# ANN ARBOR HISTORIC DISTRICT COMMISSION

## Staff Report

**ADDRESS:** 549 S First Street Application Number HDC24-0095

# **549 S 1ST STREET - SIDING, TRIM AND PORCH RESTORATION AND REPLACEMENT**

**WEST ELEVATION**

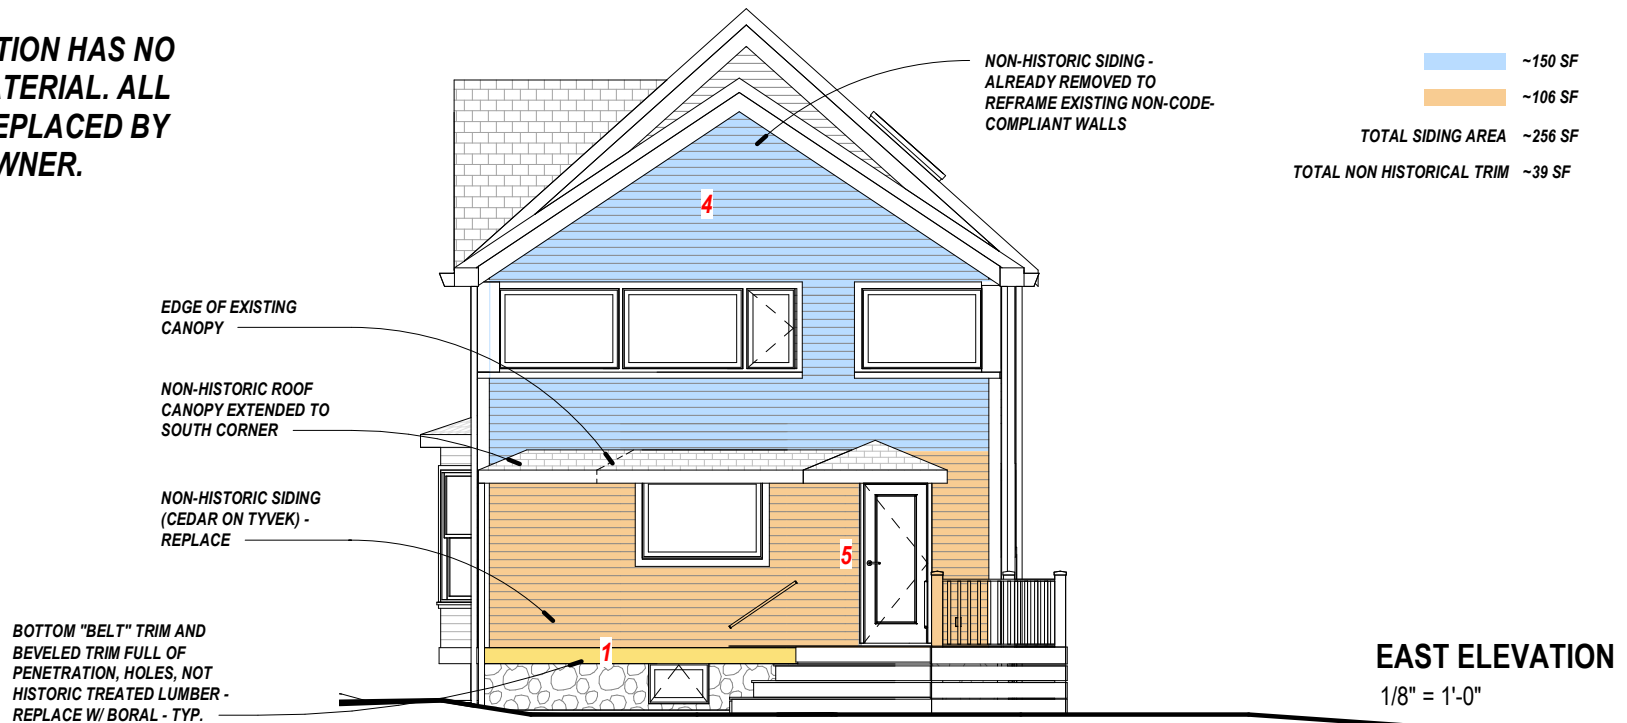
DRY ROT AND SPLITTING -  
REPLACE

REMOVE AND REPLACE FOR  
NEW ROOFING TIE-IN @ WALL

HOLES @ COLUMN TOPS, TYP.

"BLISTERING" ON FACE OF BOARDS  
BENEATH PORCH, TYP.

DRY-ROT, SPLITTING, SCREWED  
THROUGH FACES -  
REPLACE

BOTTOM "BELT" TRIM AND  
BEVELED TRIM FULL OF  
PENETRATION, HOLES, NOT  
HISTORIC TREATED LUMBER -  
REPLACE W/ BORAL - TYP.

SIDING DRY ROT AND SPLITTING -  
REPLACE

SPLIT BOARD -  
REPLACE

SPLIT BOARDS -  
REPLACE

DRY-ROT AT COLUMN BOTTOMS, TYP. -  
REPLACE

SPLIT BOARDS BEYOND -  
REPLACE

**FRONT PORCH CONCEPT  
SECTION**

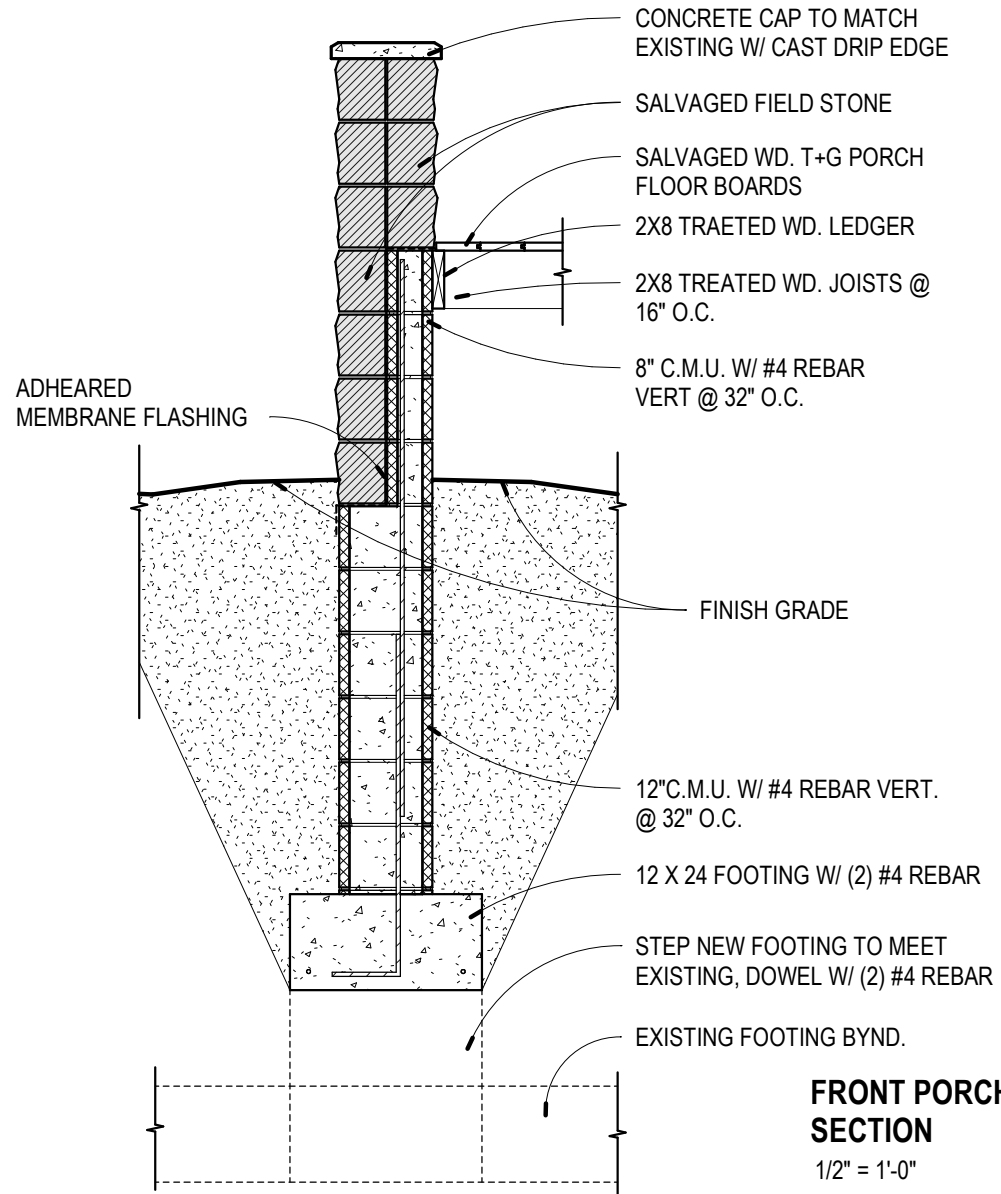
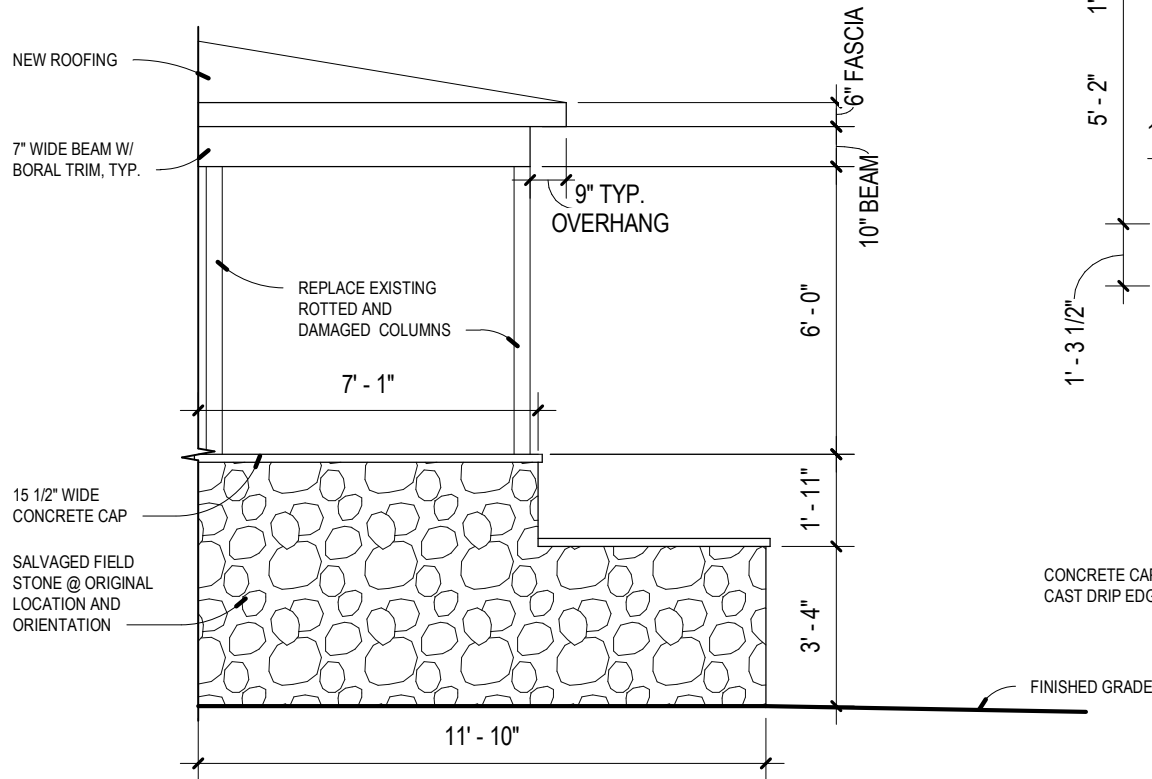
1. The existing porch foundation walls have been previously approved by the HDC in our first application to be reconstructed using reinforced concrete block below grade, and to repair/re-mortar the existing stones in their original locations above grade.
2. Upon construction, we also found that the existing porch structure is compromised and requires repair:
  - a. It is falling apart with rotted and damaged columns and dry-rotted porch floor boards.
  - b. The wood framed floor structure is integral to the field stone walls, and therefore would need to be deconstructed.
  - c. The wood framed floor structure does not meet current building code
  - d. There is an abundance of non-historic aluminum wrapping around the structural roof beams, fascia, and overhangs.

SOME 1X3 T+G  
PORCH FLOOR  
BOARDS ARE  
DRY ROTTED

1. We would like to restore the porch to its original appearance by replacing rotten and damaged material documented in this application:
  1. Reconstruct the porch floor structure to meet or exceed current building code
  2. Remove the non-historic aluminum wrapping around the structural roof beams, fascia, and overhangs, preserving any intact historic trim underneath, and replacing where necessary with identical material and style
2. We propose to replace the existing metal porch roofing with a membrane roof, which requires careful removal and salvage of abutting siding.
